Commonwealth Edison

Subject: LaSalle County Station Units 1 and 2
Control of Heavy Loads - Phase II
NRC Docket Nos. 50-373 and 50-374

Response to EG&G Idaho DRAFT TER (Phase II)

CN-24500 "L" Shaped Path Limit Switch
Arrangement Path in Ceiling

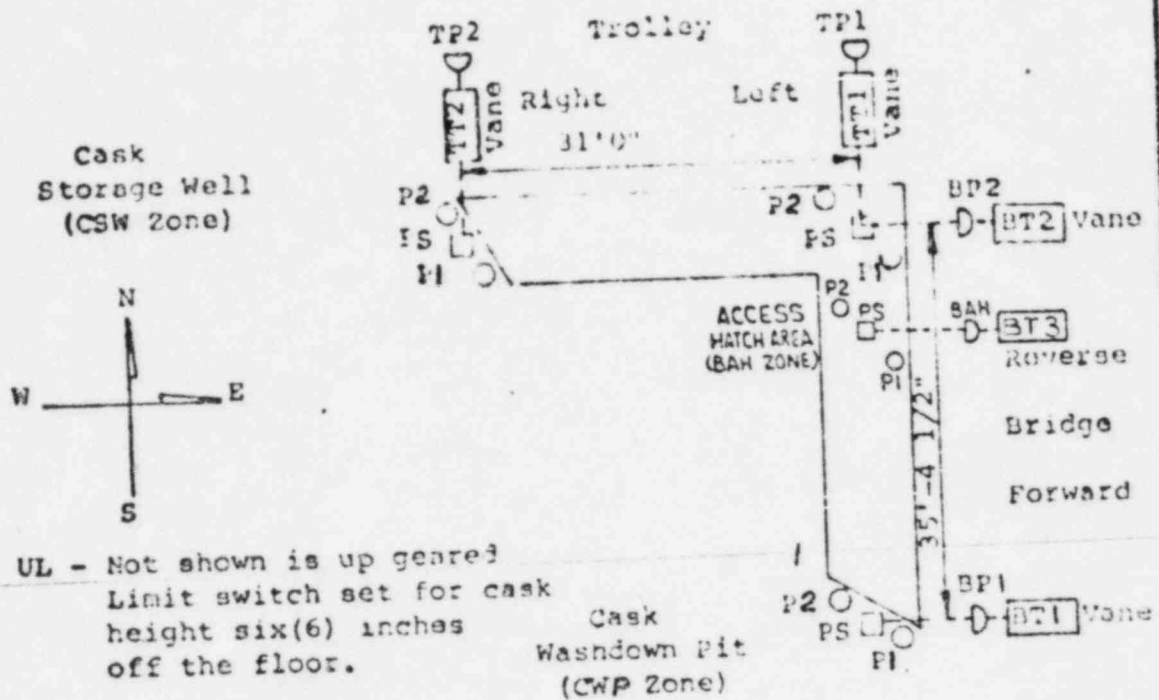
...The applicant states that dependence for meeting the criteria is placed on limit switches and upon site-specific considerations. However, no information is provided of the details of these considerations or on how the limit switches can or may be removed or bypassed...

In response to the above question and to the clarifying remarks of the August 3, 1983 telecon between the NRC, EG&G, CECO and S&L, a technical description "CN-24500 Critical 'L' Path Devices and Electrical Operating Procedure for Handling Fuel Cask" is attached (Attachment 1). As can be seen on page 3 of Attachment 1, the control switch is key operated. In addition, technical specification 3.9.7.a requires the control system be used for all cask movements. And finally a LaSalle specific operating procedure will be developed when a cask and lifting yoke (if required) are procured for the LaSalle County Station.
